# ADDENDUM

ADDENDUM NO: 2

PROJECT: Hamilton Heights High School Phase 2 Projects

DATE: 02/27/2024

DRAWING TITLE:  
AGRICULTURE  
FOUNDATION  
PLAN

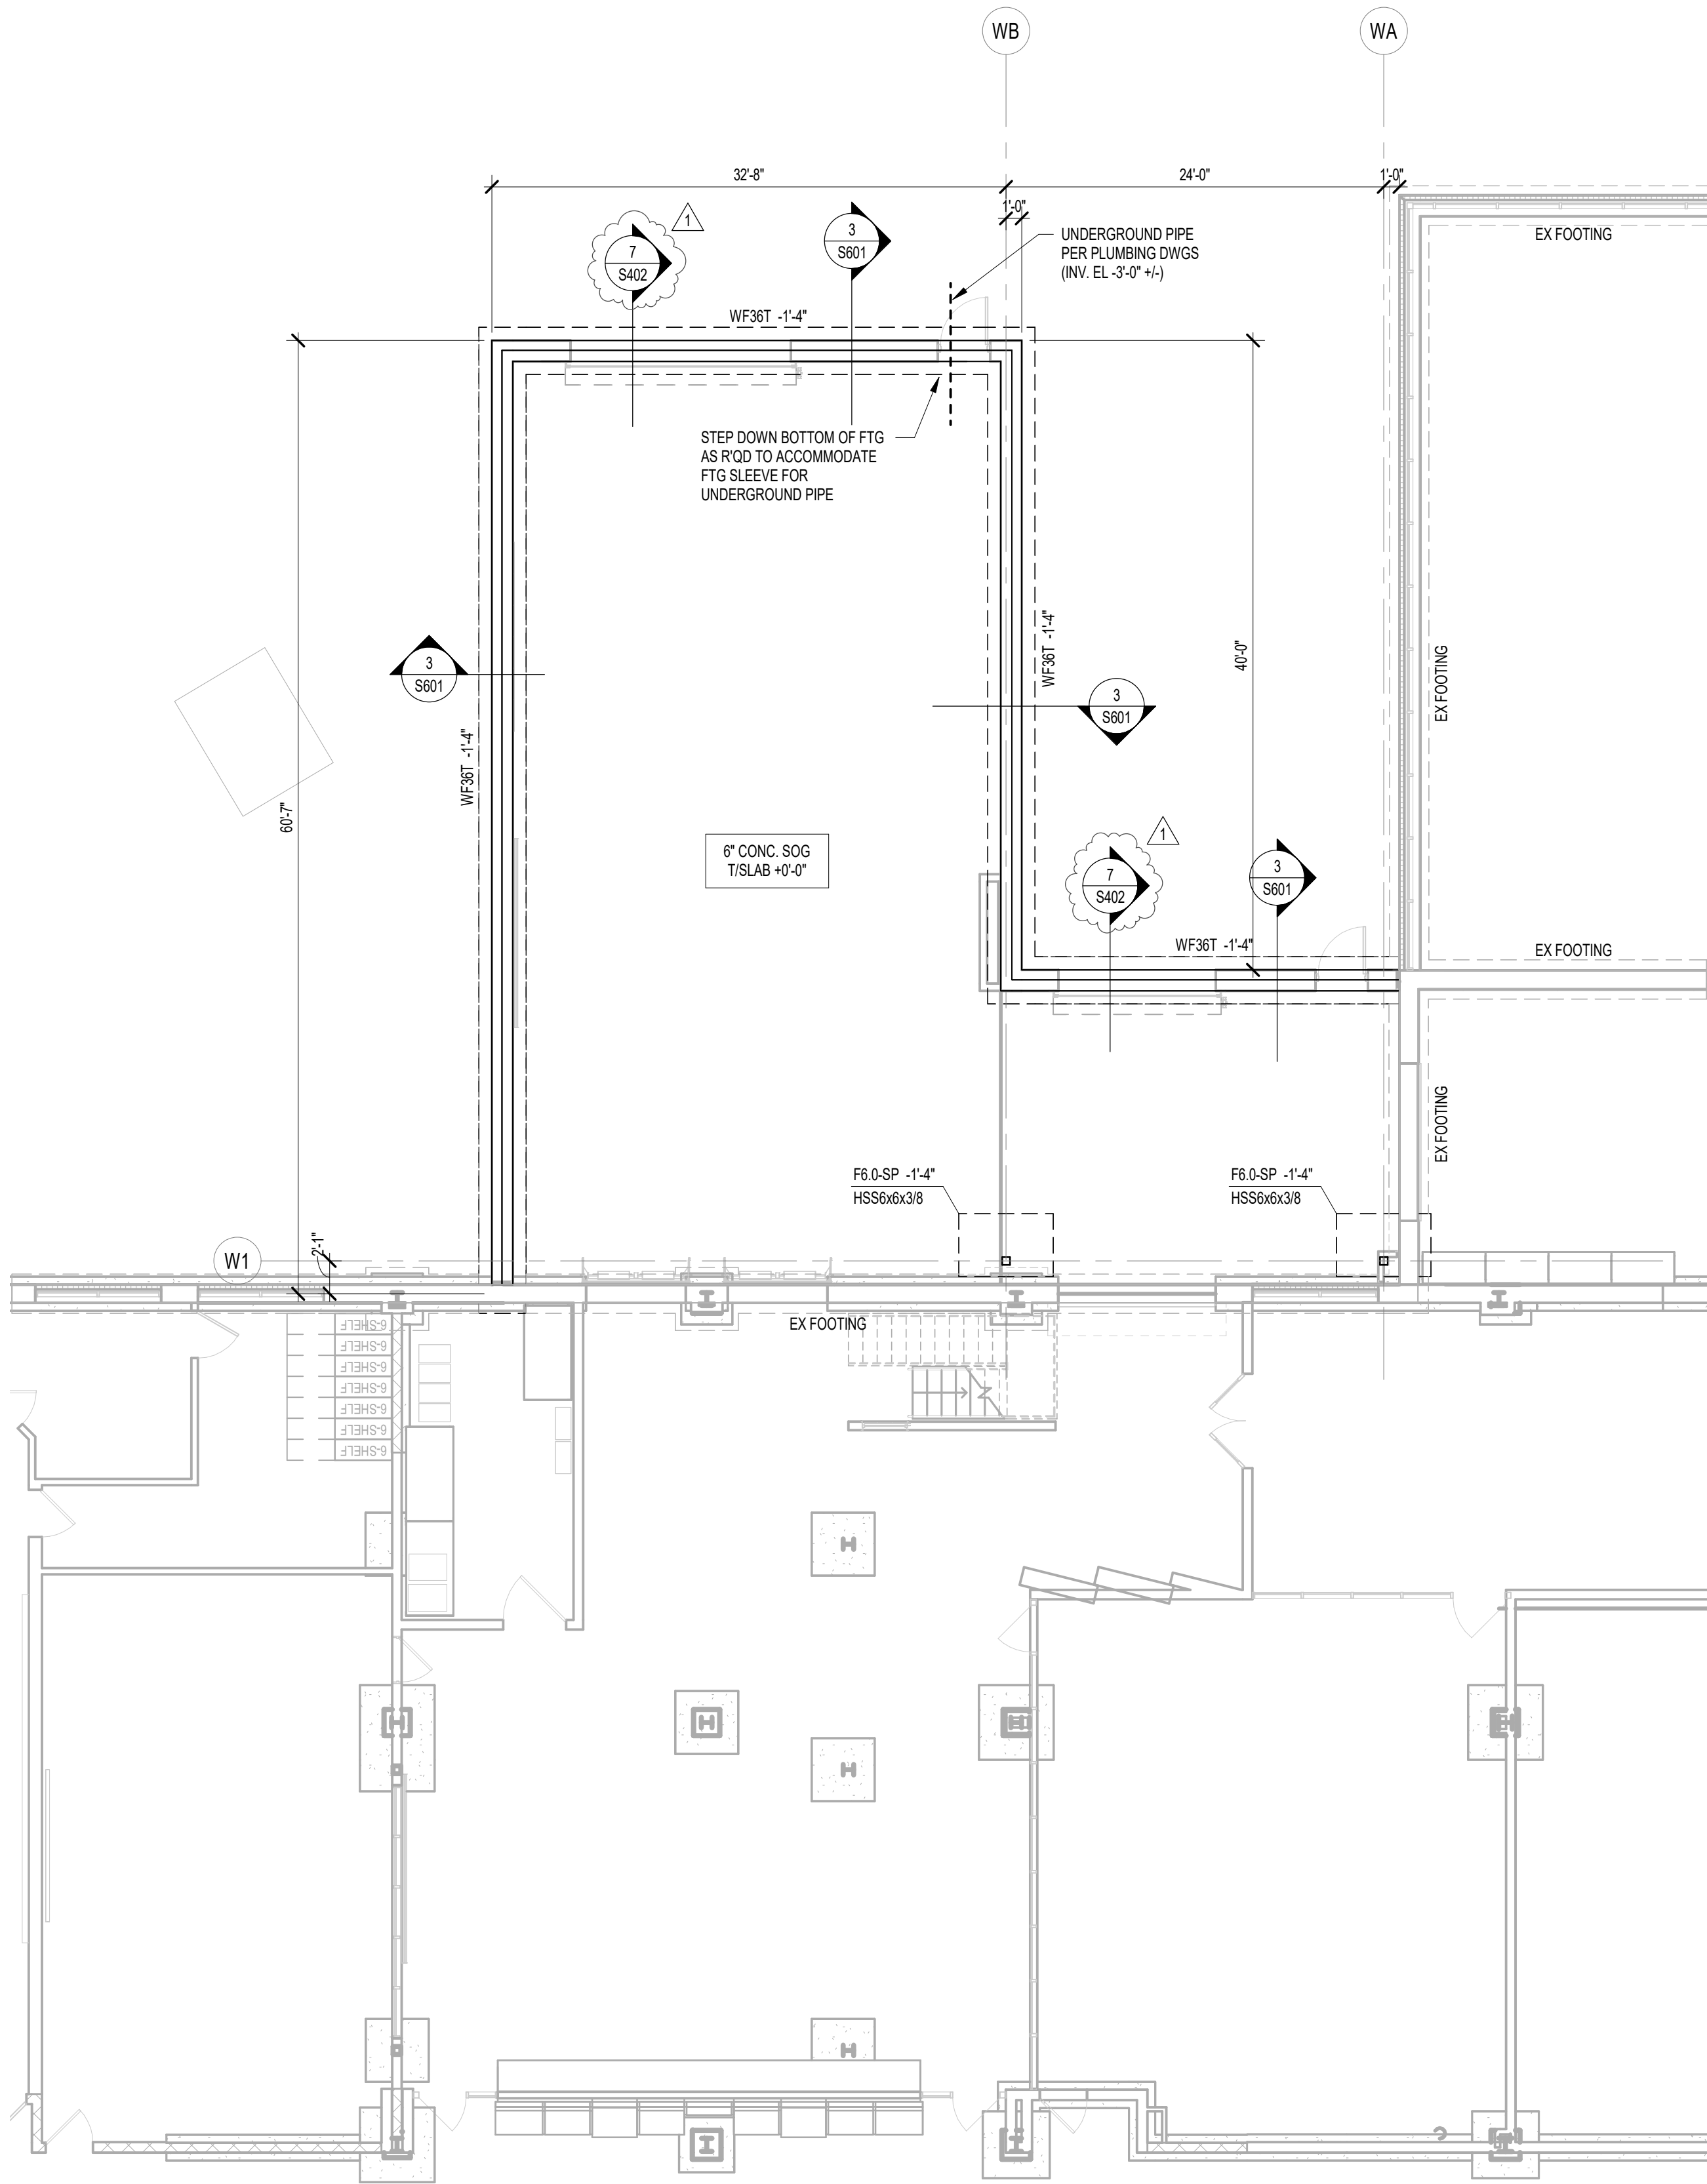
3.14 S102 – AGRICULTURE FOUNDATION PLAN

- A. New foundation section at the overhead doors shall be added as shown on the attached drawing.

DRAWING TITLE:  
**OUTBUILDINGS  
ROOF FRAMING  
PLANS**

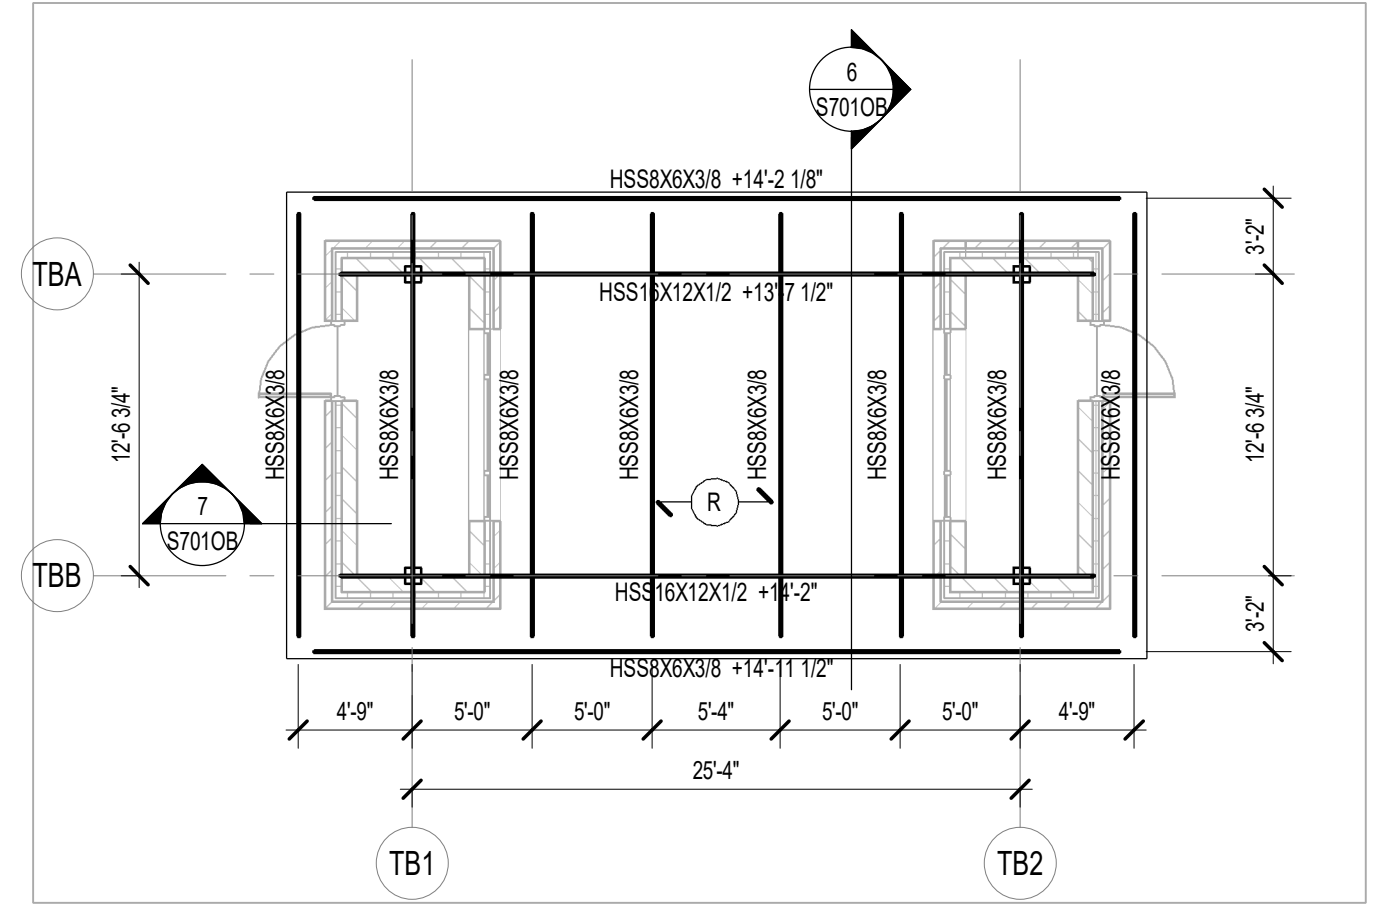
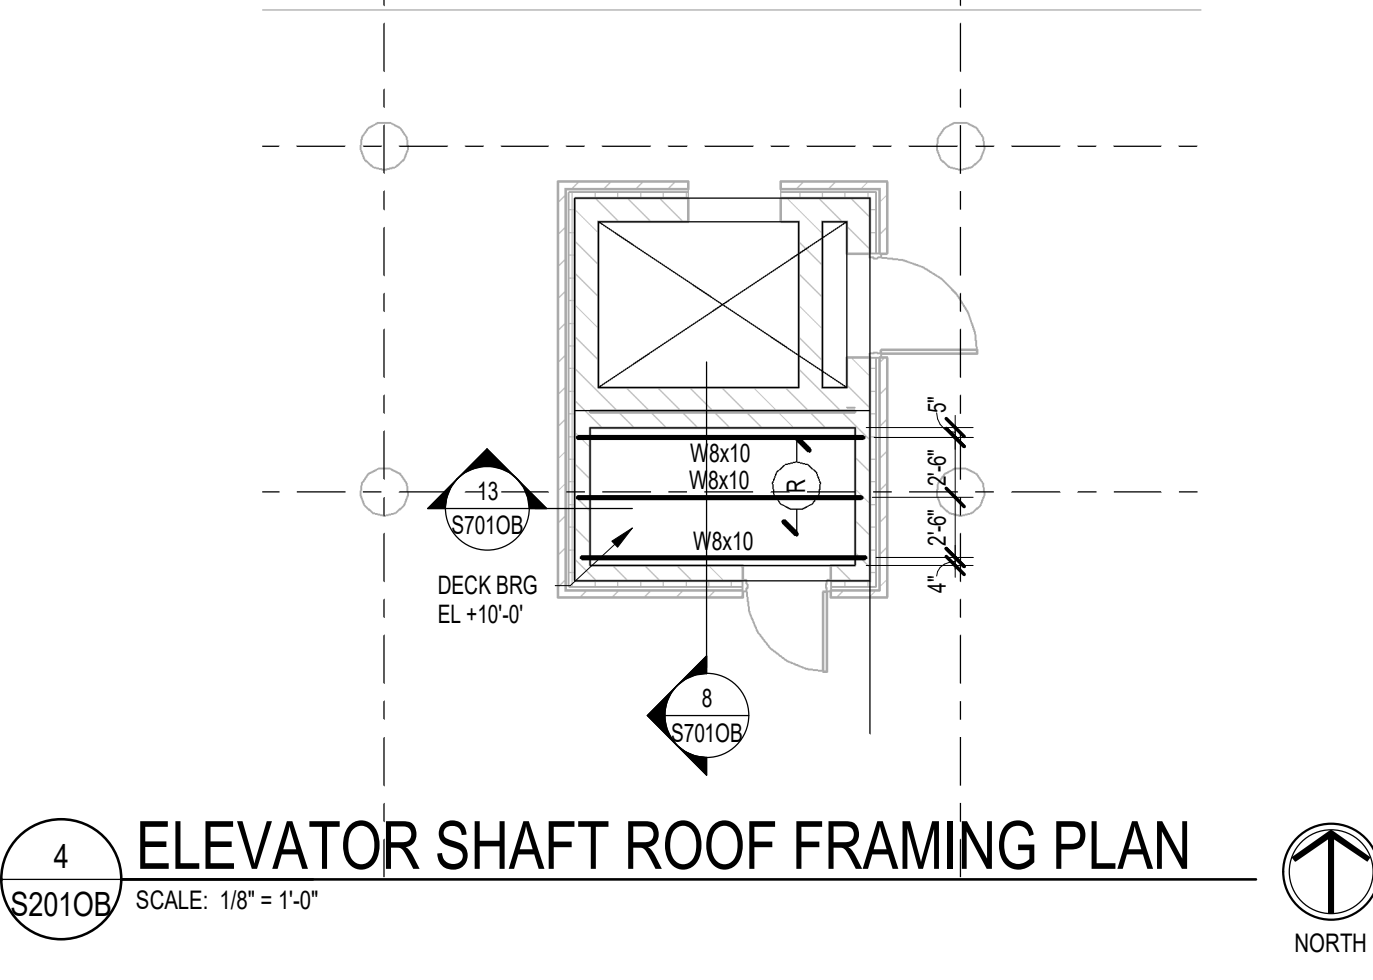
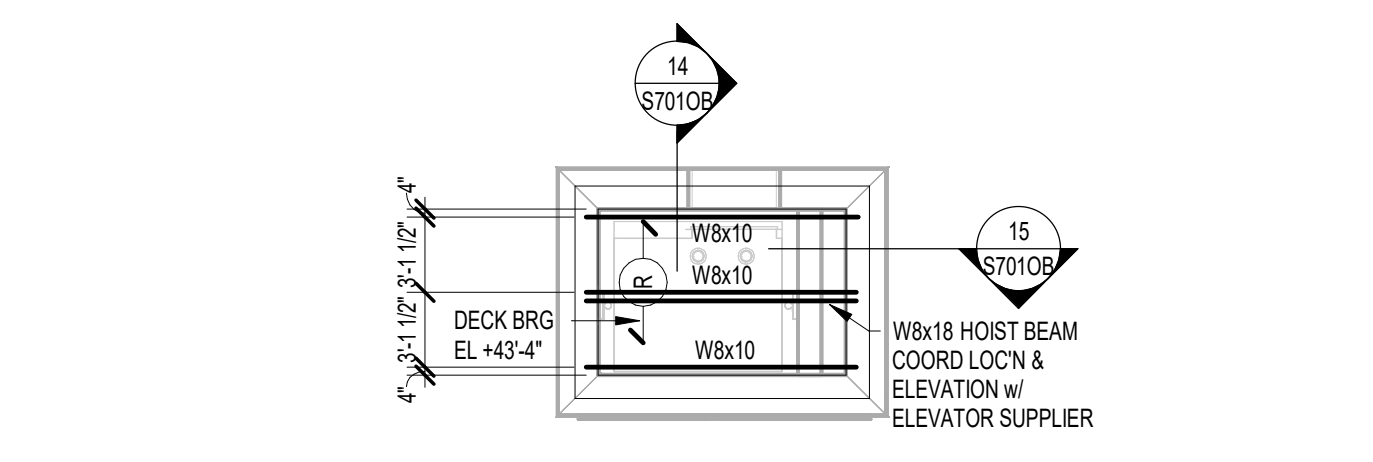
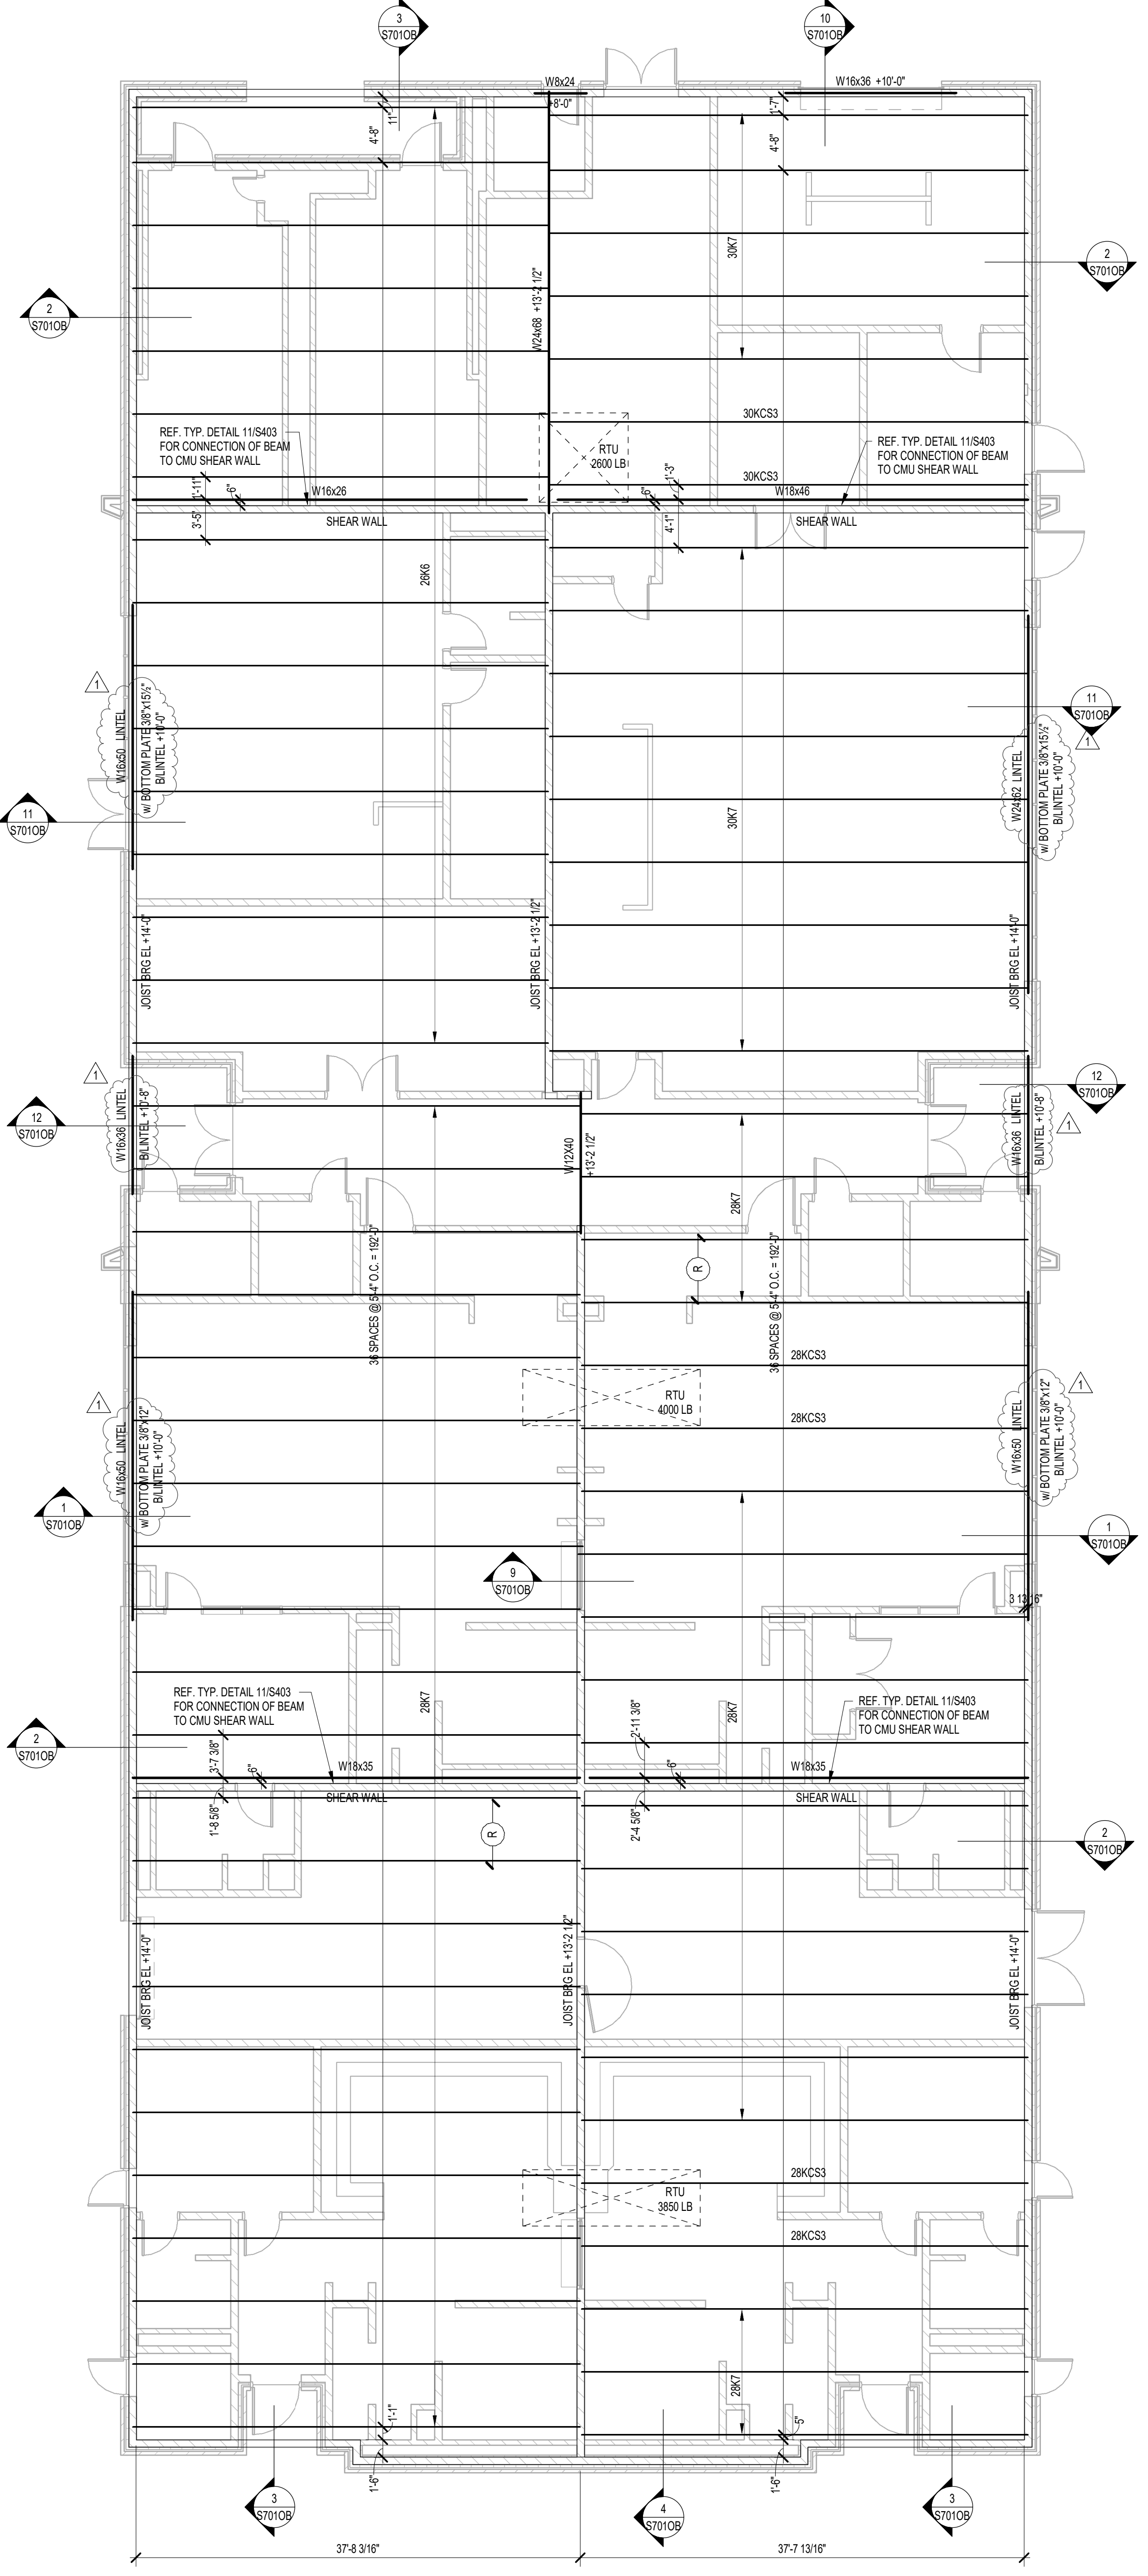
3.15 S102OB – OUTBUILDINGS ROOF FRAMING PLANS

- A. Masonry lintel callouts at the locker room building shall be revised shown on the attached drawing.
